Issue List

- NONFUNCTIONAL/INACCESSIBLE DAMPERS
- RIGID DUCT NOT INSTALLED

03-02-26 CULVERS - MESA, AZ

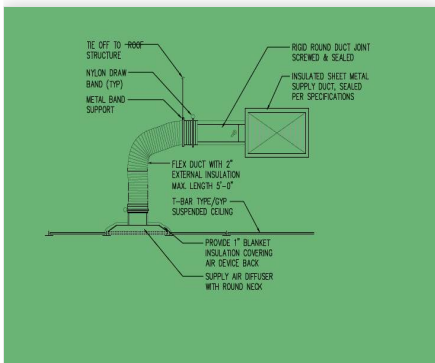
Issue Name : NONFUNCTIONAL/INACCESSIBLE DAMPERS
Description : SGRD1-7: Flow varies between 345-380cfm regardless of lever movement (DR). Some dampers are covered by insulation and the cable tie.
Created By : National TAB **Assigned To :** National TAB - Brianna Biggs
Status : Open
Priority : Urgent **Asset Tag :** SGRD7
Originated Date : 03/06/2026 - Christine Weale - National TAB
